03/08/2021
CAL FTL 49-002

Subject: Adding Exhaust Shim to ATS Exhaust Outlet and Replacing Exhaust Elbow and Clamp

Models Affected: Twenty-Three Freightliner New Cascadia vehicles manufactured on January 4th, 2021 through January 7th, 2021

Fig. 1, Horizontal Exhaust Pipe Installation

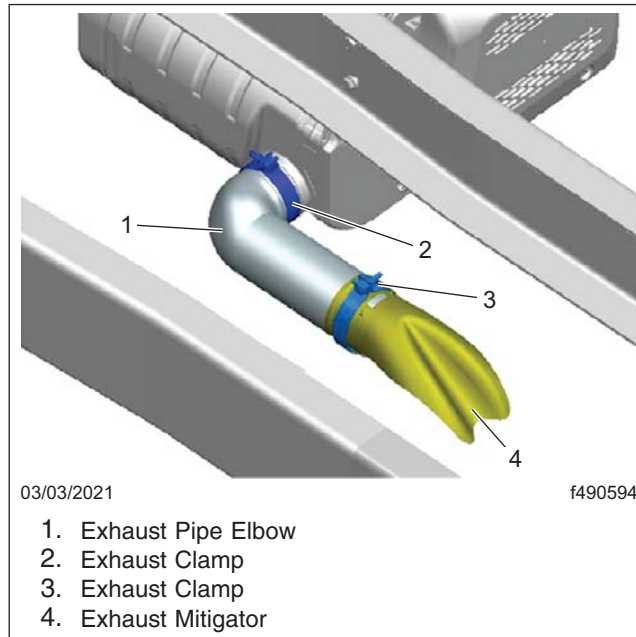
3. If a supplemental restrain system (SRS) is installed, disconnect it.
4. Disconnect all wiring from electronic control modules near the weld site.
5. Attach the ground electrode as close as possible to the weld site (within 18 inches (46 cm)). Remove paint, rust, and grease to provide a clean, bare-metal connection for the ground electrode.
6. Remove and discard the exhaust clamp located at the ATS outlet; see callout 2 in [Fig. 1](#).

7. Remove the exhaust assembly and then remove the exhaust clamp that attaches the exhaust mitigator to the exhaust elbow pipe. See [Fig. 1](#).
8. Discard the exhaust elbow pipe.
9. Assemble an exhaust assembly from the new exhaust elbow pipe (part number 04-34491-001), exhaust mitigator, and exhaust clamp. Ensure the exhaust elbow pipe is inserted until stopped by the tab on the exhaust mitigator. See [Fig. 2](#). Torque the clamp fastener to 41 ± 6 lbf·ft (55 ± 8 N·m). Set the exhaust assembly aside.

Fig. 3, Installation of Shim on the ATS Outlet

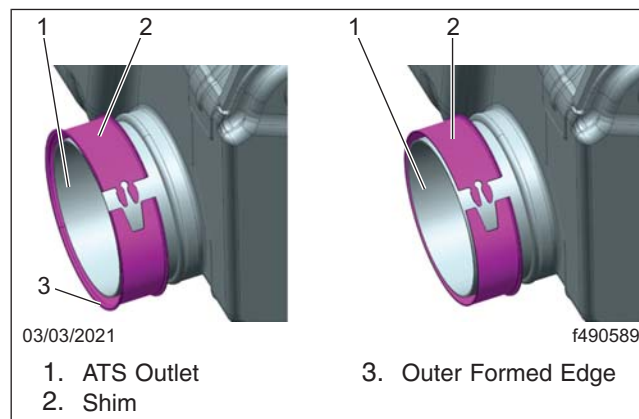
10. Place the provided ATS exhaust outlet shim on the ATS outlet with the groove in the shim at the top. The outer formed edge will need to be trimmed approximately .11 in (3 mm) to allow for the exhaust elbow pipe to fit over it. See [Fig. 3](#). Using a metal ruler, ensure the shim is flush with the pipe. See [Fig. 4](#).
